**BOARD OF ZONING APPEALS  
CITY OF PRAIRIE VILLAGE, KANSAS  
AGENDA  
July 12, 2016  
6:30 P.M.  
\*\*IN MULTI-PURPOSE ROOM\*\***

BZA2016-05 Request for a Variance from PVMC 19.06.030(A) to allow a New home to encroach the required 14' separation between dwellings by 1.5" to 2.5"  
3009 West 71<sup>st</sup> Street  
Zoning: R-1a Single Family Residential District  
Applicant: Debra Hudacek

# STAFF REPORT

**Application:** BZA 2016-05

PLOT PLAN - 3009 W. 71<sup>st</sup> ST.  
SCALE 1" = 20'  
SCURATO RESIDENCE

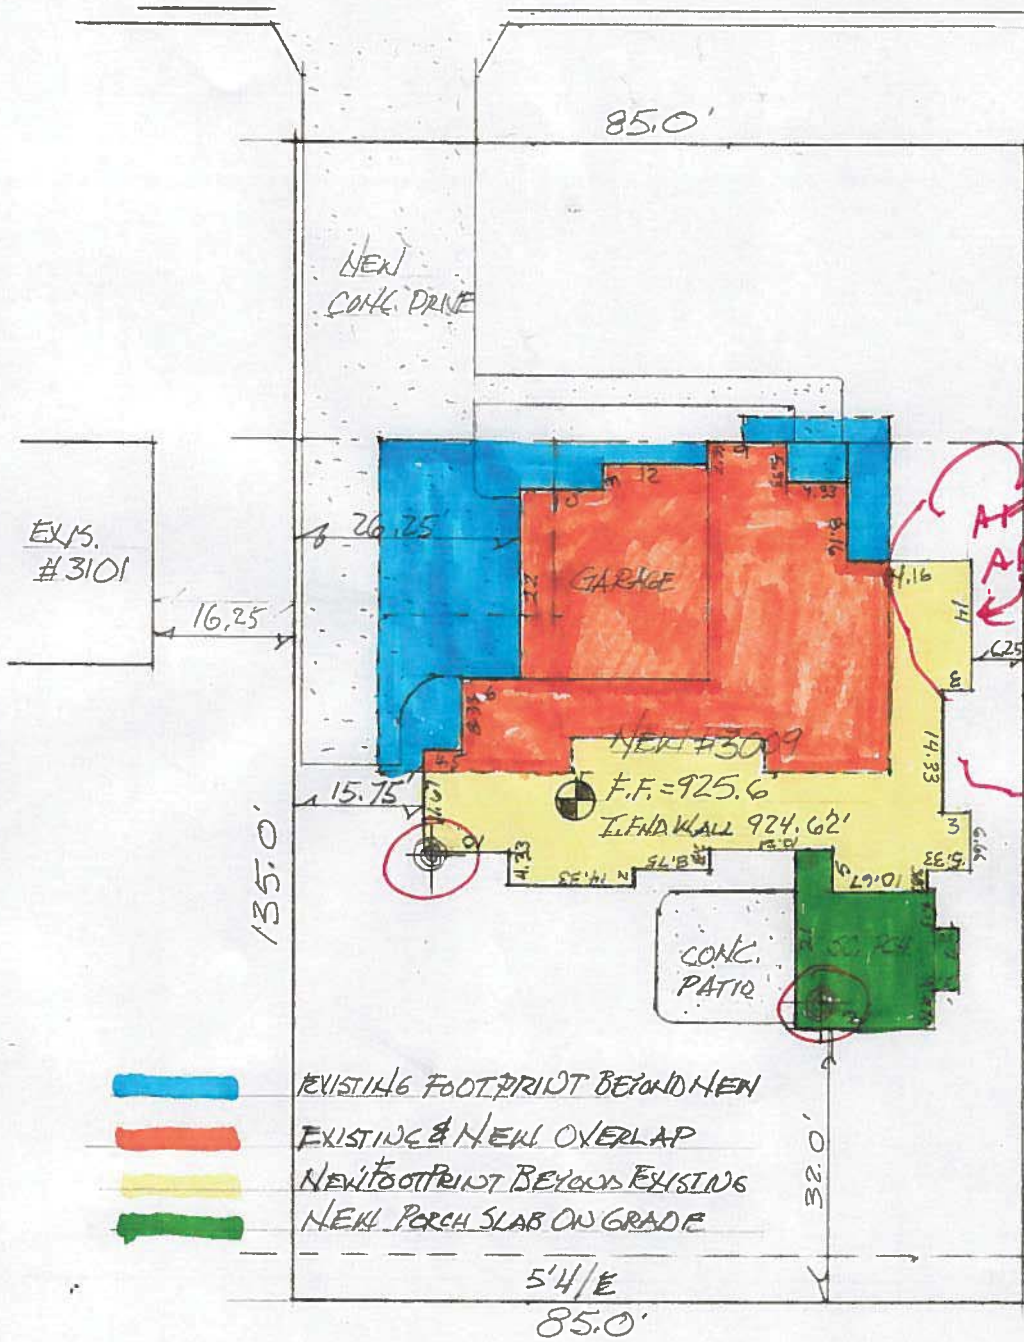
Criteria #1 The new foundation is 1 ½ inches to 2 ½ inches to close to the foundation of the neighboring foundation. This is the result of an error in a survey notation not discovered until after construction was well under way. This occurs at two 4' ½" sections of the east wall. The majority of the house is well inside the setbacks required.

Criteria #2 The framed wall of the house is allowed to reside in it's current location, only the foundation wall is outside the required setback. Therefore, the foundation is not affecting the position of the exterior wall of the house.

Criteria #3 The home is framed and roofed. Wiring and plumbing and HVAC was complete at the time of discovery of the issue. Relocating two small sections of foundation would be costly and difficult at this time. It would also not affect the position of the framed wall.

Plot Plan - 3009 W. 71<sup>st</sup> St.

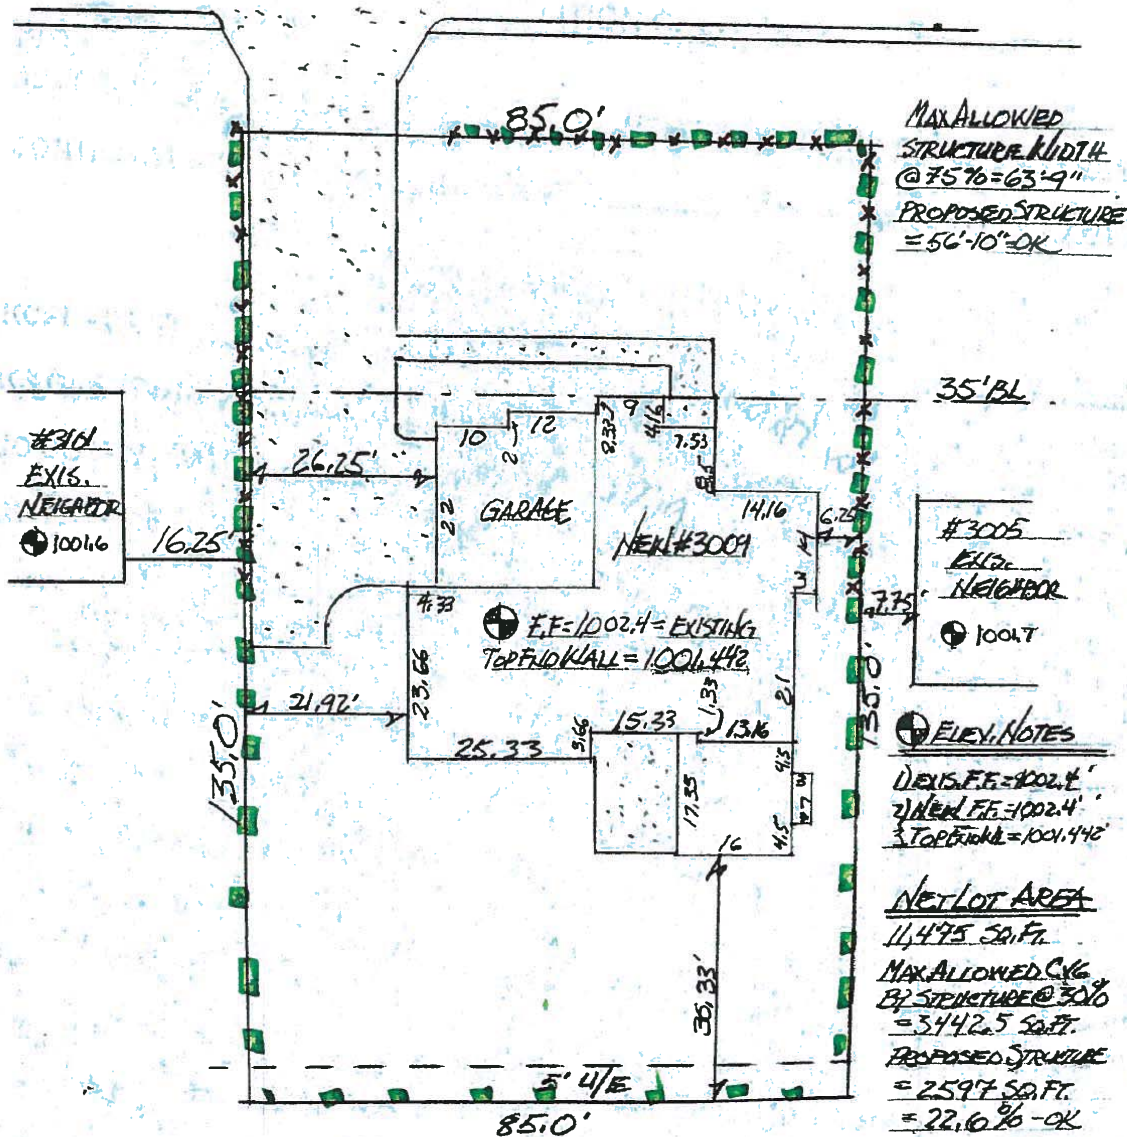
City of Prairie Village Kansas Building Codes Department Plan Review comments  
Address: 3009 W 71<sup>ST</sup> Street Date: 2-16-2016

- New structure foundation shall maintain 14' clearance between adjacent structures foundational elements. Shall be clarified by sealed survey and reported at time of footing.

FOOTINGS CERTIFICATION: 3/1/2016

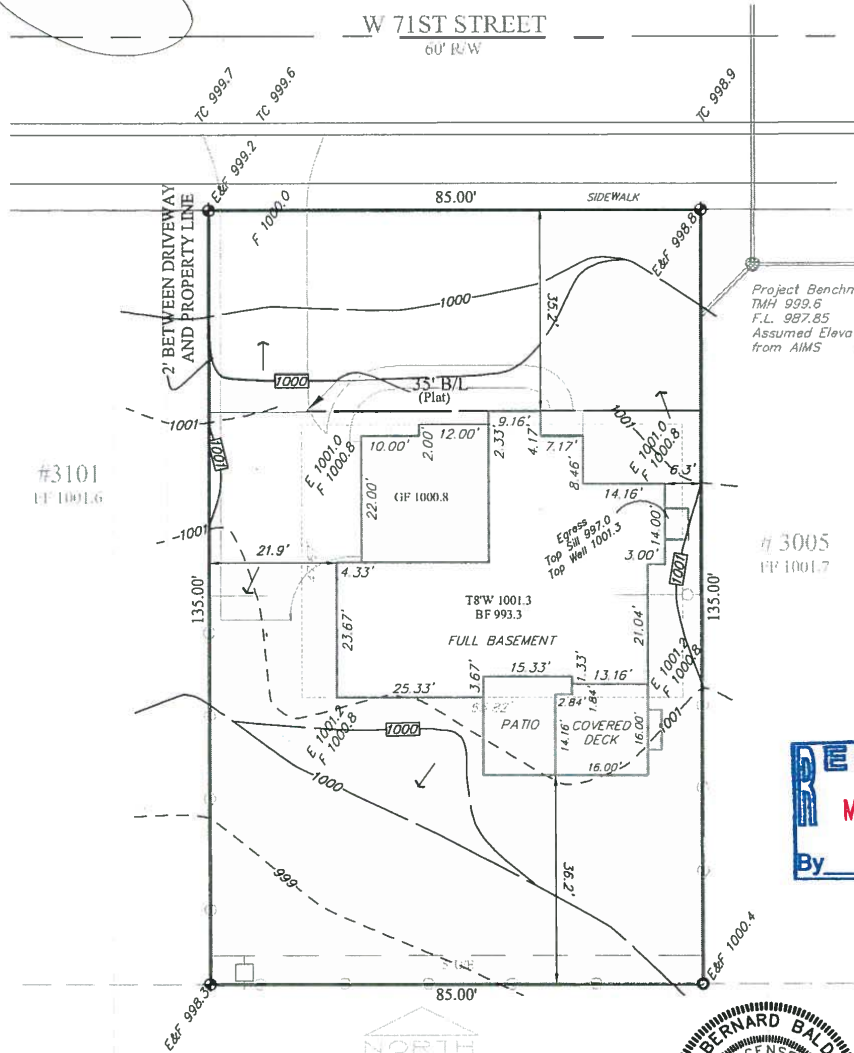
I hereby certify that the existing footing forms on this date are placed in accordance with the below Plot Plan, which is based upon the Site Plan performed by Land Survey Company, dated February 10, 2016, and approved by the City of Prairie Village.
